Facility Impact and Funding Committee (FIFC) Report

6-July-2007

To evaluate validity and feasibility of the experiments planned in the Hadron Experimental Hall of J-PARC, the Facility Impact and Funding Committee (FIFC) of the Institute of Particle and Nuclear Physics (IPNS) was set up in the fall 2006.

Fig.1 The detector setup for E03

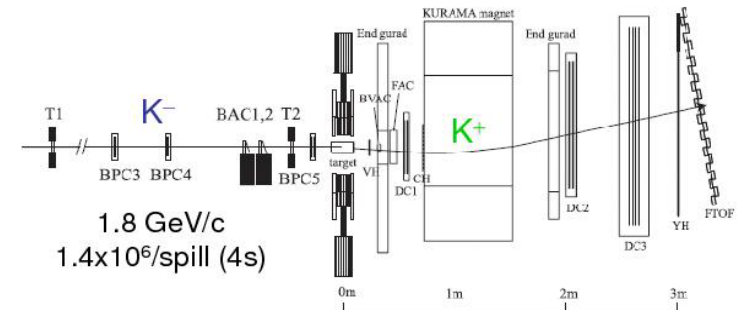
- 1) In the proposed apparatus, the Ge detector arrays are placed in a wall shape around the target which may loose the effective solid angle when compared with the ball configuration. The reason to use the wall configuration is explained that the guard plates of the Kurama magnet conflict with the placement of the refrigerator of the Ge detector. One possible solution to use the ball type configuration is to replace Kurama with SKS, however, the yield of usable kaons become half when compared with original proposal in this case. The committee recommends to estimate the overall efficiency for these two cases quantitatively and to take the better choice.
- 2) It is reported that the estimated DAQ dead time is 25% in the typical condition and can become up to 50%. The dead time is explained to come from the slow signal response of the Ge detector. However, it is equivalent to loose such a

large amount data of more than 25%, and the experiment group should pay more attention to the reduction of the dead time. The committee suggest to think about the possibility to use the wave form sampling readout which may help to reduce the dead time.

- 3) Because of the slow signal response of the Ge detector, the peak shift and width broadening depending on the hit rate are crucial problems to obtain the required energy calibration of less than 0.05 keV. The experiment group proposes two different methods for the calibration, one is to have special runs dedicated for the calibration using the strong source, and the other is to use the scintillator embedded source which enables the simultaneous data taking with the real data. The group put the emphasis on the first method, however, it requires dedicated runs frequently in order to keep track the change of the hit rate which may occupy more than 10% of the beam time. The committee suggest to explore the second method as possible which can truly monitor the rate dependence in the real data without disturbing the data taking.

- 4) The current estimation of continuous X-ray background is based on the measurements at E419 of the (π^+, K^+) reaction, and it may not describe the real background rate in (K^-, K^+) reaction correctly. It is also pointed out that there may be a dependence on the background shape in the X-ray peak shift and the width. The experiment group is asked to study these issues more in detail by utilizing the existing data.

Figure 1: S/N ratio as a function of energy resolution in the case of the ${}^6_{\Lambda}\text{H}$ production. For more details see the text.

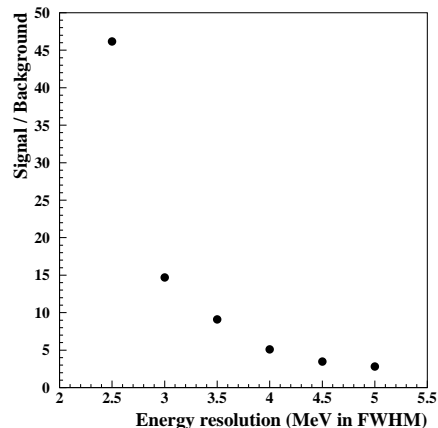
Q4 : Can you show us the significance of signals as a function of energy resolution in order to verify the 2.5MeV (FWHM) requirement ?

A4 : Figure 1 is a result of the calculation of the S/N ratio in the case of the ${}^6_{\Lambda}\text{H}$ production. In the calculation, the energy threshold of particle decay channels in ${}^6_{\Lambda}\text{H}$ is assumed to be 3 MeV. The ratio of yields between the signal (hypernucleus production) and the background (quasi-free Λ production from $0 < -BE < 20\text{MeV}$) is assumed to be 1:10. These parameters are same as that used in the discussion described in the document for FIFC (see Fig.2 in the document). The energy window for signal selection are set to $\pm 2\sigma$ (σ is the energy resolution in rms).

The result shows the signal is quite significant in the case of the 2.5 MeV resolution. The S/N ratio drops quite rapidly with the increase of the energy resolution.

Figure 2: Simulated hit distributions at DC1 and DC2. Black and red colored histograms corresponds to hypernuclear events and beam hits, respectively. See text for more details.

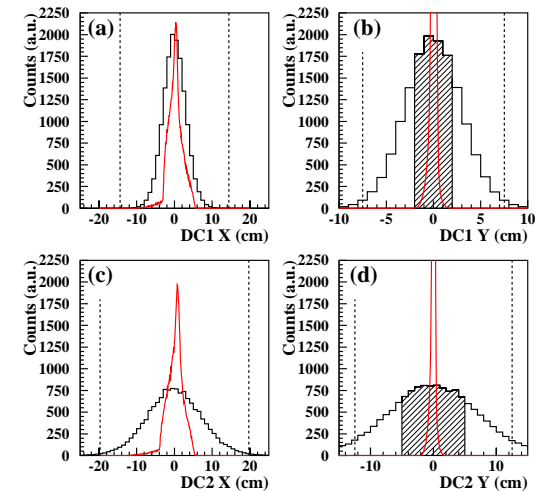
Q7 : Can you show us K^+ distribution in DC1, DC2 together with the beam ?

A7 : Figure 2 shows simulated hit distributions at DC1 and DC2. The distribution projected to the x (a) and y (b) axes at DC1, and the x (c) and y (d) distributions at DC2. The black colored histograms correspond to events with the production of hypernuclei, and red colored histograms correspond to beam hit distributions.

For the simulation, the angular dependence of the differential cross section of the production cross section of hypernuclei is included in the black histograms, but the SKS acceptance is not included. The SKS acceptance changes the x distributions, (a) and (c), a little. For the y distributions, (b) and (d), the hatched areas roughly show the SKS acceptance.

The vertical dashed lines indicate the edge of DC1 and DC2.

Figure 3: Hit profile change from BC3 to the final focus point (FF) in the x (horizontal) direction.

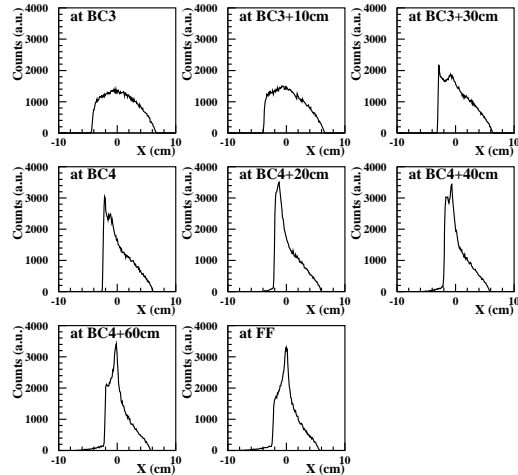
Q12 : Can you explain the beam distribution in BC4, p.11, especially the sharp edge in left ?

Figure 3 shows the hit profile change from BC3 to the final focus point (FF) in the x (horizontal) direction. The beam focusing becomes significant around BC4 position. The peak structure at the left end at the BC4 position seems to move toward center ($x=0$) from BC4 to FF.

We wish to mention that the BC4 x profile is quite asymmetric in shape, but the asymmetric profile causes no technical problems in the E10 experiment.

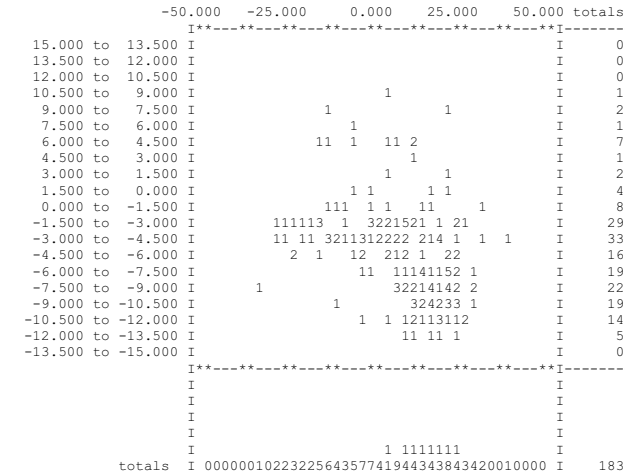
In LESBIII this collimator is located upstream of the first separation stage and allows independent variable cuts in the 4 corners of x-y phase space. The collimator is located in a place where x and y at the collimator correlate well with theta and phi at the target, so a x-y cut will reduce the theta-phi phase space allowed into the separation stages. This was important for LESBIII due to the very large theta and phi acceptance (~ +/- 200 and 20 mr full width respectively) of the channel and allowed high order theta-phi aberrations to be controlled. Since the K0.8 beam line acceptance is only about 10% of LESBIII (theta/Phi +/- 35 and 10 mr respectively) it is probably of no consequence that this type of collimation is missing. The only caveat is the high order optics must be right, otherwise theta-phi (and dp/p) aberrations could result in tails that cannot be removed.

An example is shown in Fig. 1 below in a TURTLE simulation with the K0.8 separator at half voltage to allow pions to the end of the beam line. The histogram shows the theta-phi phase space of those pions that are transmitted through a 4 mm IY1, 3 mm MS1 and 1.2 cm HFOC to the end (no slit scattering included). For this simulation the pions were given a positive 1.25 mr phi kick in the separator. The number of pions transmitted to the final focus in this simulation roughly translates to 1:1 π /K. If a suitable location for a phi collimator could be found such as between the first sextupole and the separator (see Fig. 2.) this could provide an additional handle on direct pion contamination.

Recommendation: Investigate the possible addition of a variable vertical collimator upstream of the separator to reduce phi acceptance. Note this collimator need only have one jaw either top or bottom depending on the polarity of the separator.

Fig. 7. x-y histogram of cloud pions at production target gated by those that reach HFOC. Initial phase space as in Fig. 5. The ellipse shows the approximate profile of the rotating Nickel target.

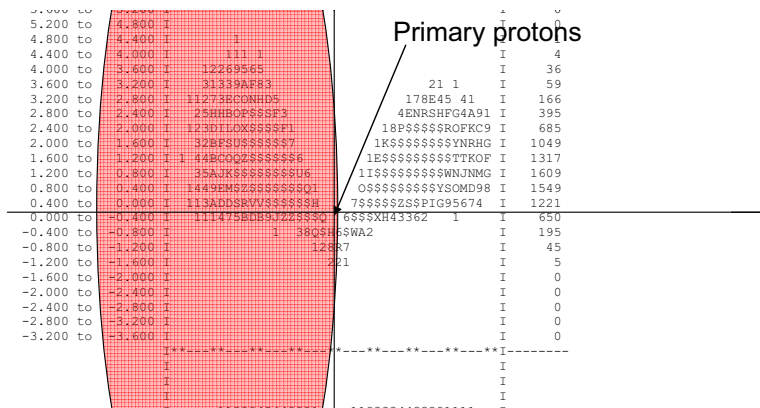
The LESBIII target was designed with respect for the potential for a pion source that originates in material either in the target or its holder. Fig. 7 is an x-y histogram of cloud pions at the production target of K0.8 gated by cloud pions that are transported to the HFOC. The separator is at full field and initial phase space is as was outlined in Fig. 5. As can be noted the x-y area nominally traversed by the beam has no events so the elimination of direct pions is good. The case was similar for the LESBIII beam line and the target and holder were designed so as to not overlap cloud pion events. For the case of a positive phi kick in the separator as in the simulation that was used to generate the histogram in Fig. 7, this would dictate a target holder that extended above the target. As I understand it the K0.8 target is a 28 cm diameter rotating Nickel disc (roughly drawn in Fig. 7) with the protons hitting an edge such that the secondary beam for K0.8 must pass through the full z extent of the target. There are then three issues with the target that I'm aware of:

These target issues were not accounted for in the Doornbos report. Since the target is only 0.3 interaction length and relatively low Z the two issues 1) and 3) above may be of little consequence but a good target model should be developed.

Recommendation: RAYTRACE (or equivalent) simulation that takes into account 3rd and higher order optics should be
